EQUIPMENT UPDATE

Log Number: EU-9-376

Part: RINSE COLLECTOR PAN

Models Affected: CMA-44 CONVEYORS

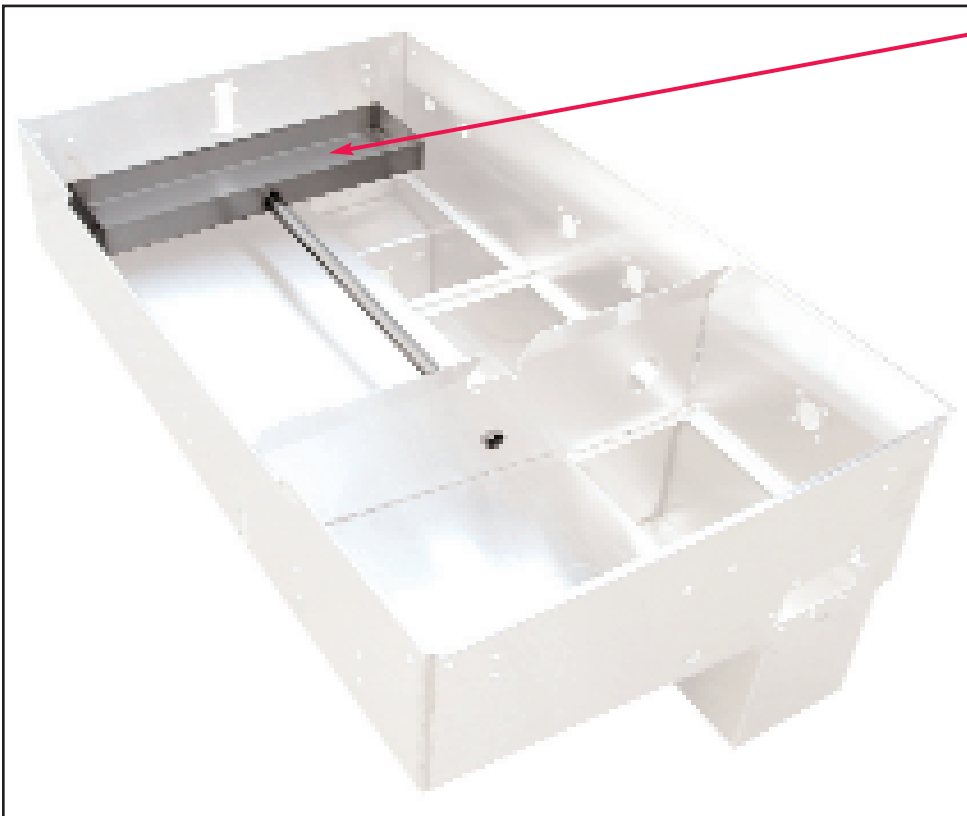
A new Rinse Collector Pan has been added to all CMA-44's. This new part will now collect about 50% of the rinse water and transfer it into the pre-wash tank. CMA, through intensive testing, has determined that this new featured item will reduce chemical usage by 30% to 40%. If you choose, the Collector unit can be easily removed. The Collector unit is held in place using (2) bolts that also secure the tray track.

New Part Number: 13560.00
